**Staff Report**  
**(with attachments)**  
**Presented to the**  
**Historic Preservation**  
**Commission**  
**July 20, 2022**

# STAFF REPORT

1306 W. MOUNTAIN AVE, FINAL DESIGN REVIEW, REHABILITATION & ADDITION

WEST  
ELEV.

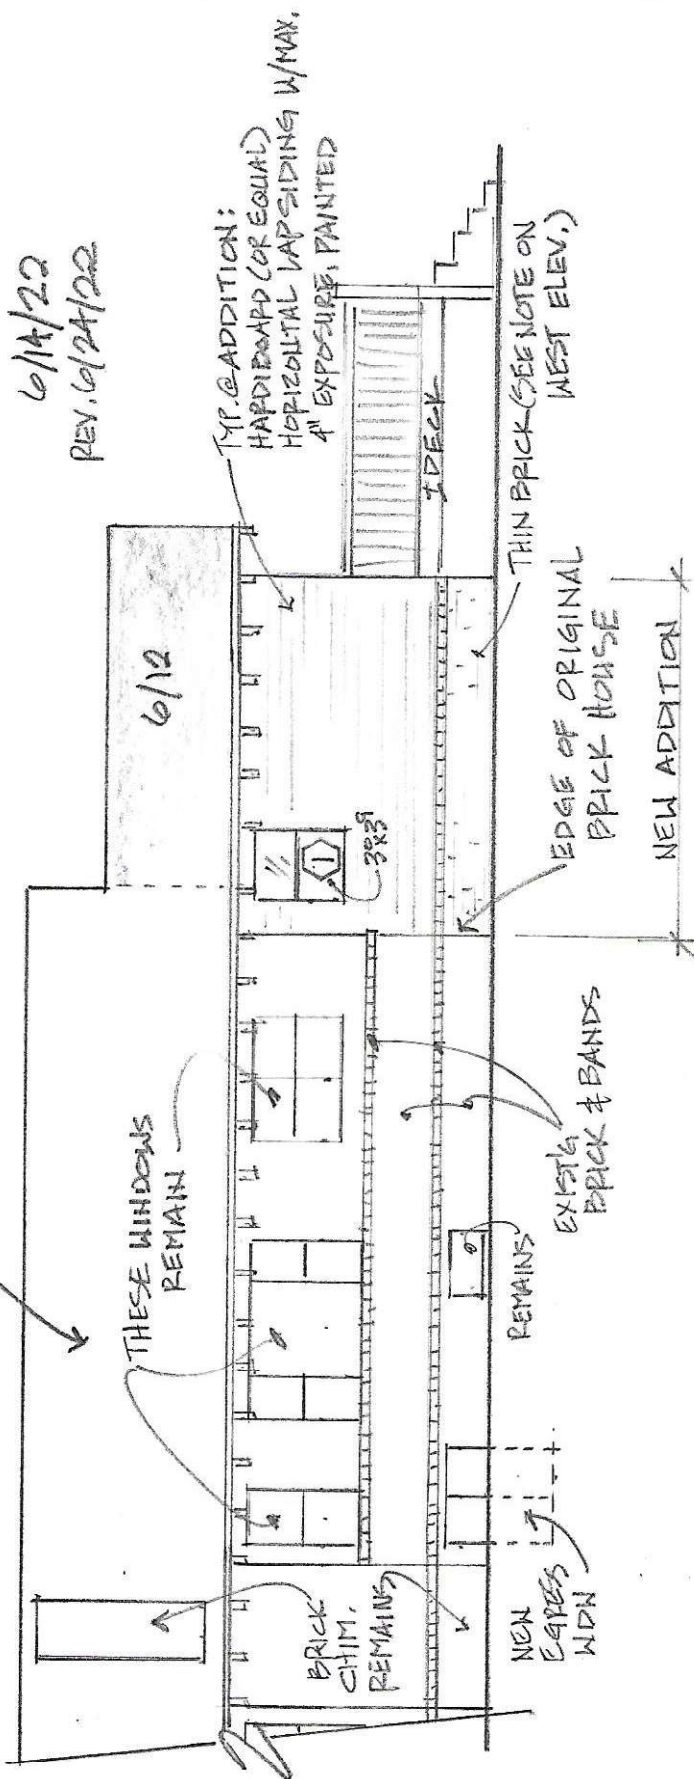
Staff finds the current proposal generally meets the *Standards for Rehabilitation* very well, but the modification to the historic west-facing window in the northwest bedroom does not appear to meet the Standards. Staff is recommending a condition to approval that the plan be altered to retain the existing window opening, not approve the proposed demolition for two new window openings in this area, and approve a casement or other egress-compliant window in the existing historic window opening. Staff has provided an analysis below.

Staff recommends that the HPC conditionally approve a Certificate of Appropriateness for the project, specifically approving the project as proposed, with the condition that the window treatment of the northwest bedroom in the historic building be modified to retain the existing window opening, delete one or both of the proposed two new window openings, and install an egress-compliant window in the existing opening.

NORTH  
ELEV.

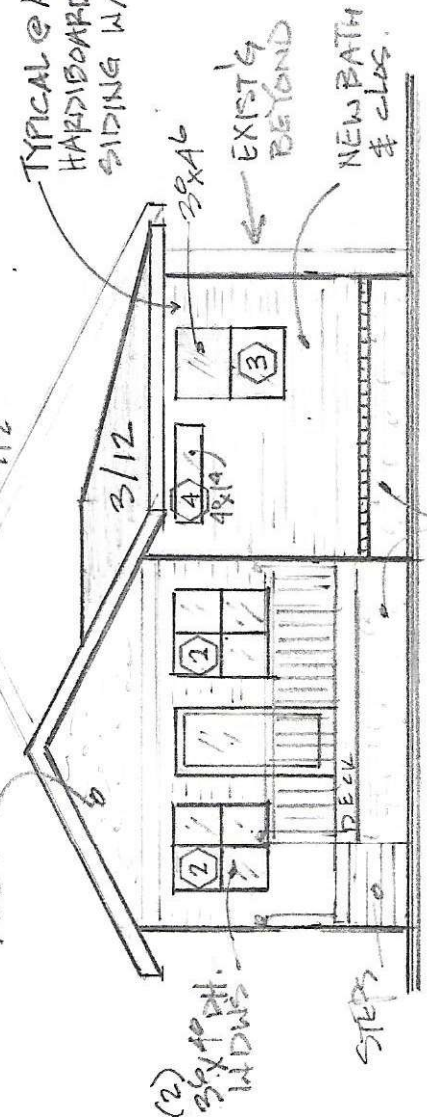
wall that was formerly along this wall section has already been removed. The modification of the north-facing window at the northwest corner of the house into a passageway into the new bathroom is a common modification to provide passage in between existing and new additions and meets this Standard.	
--	--	--
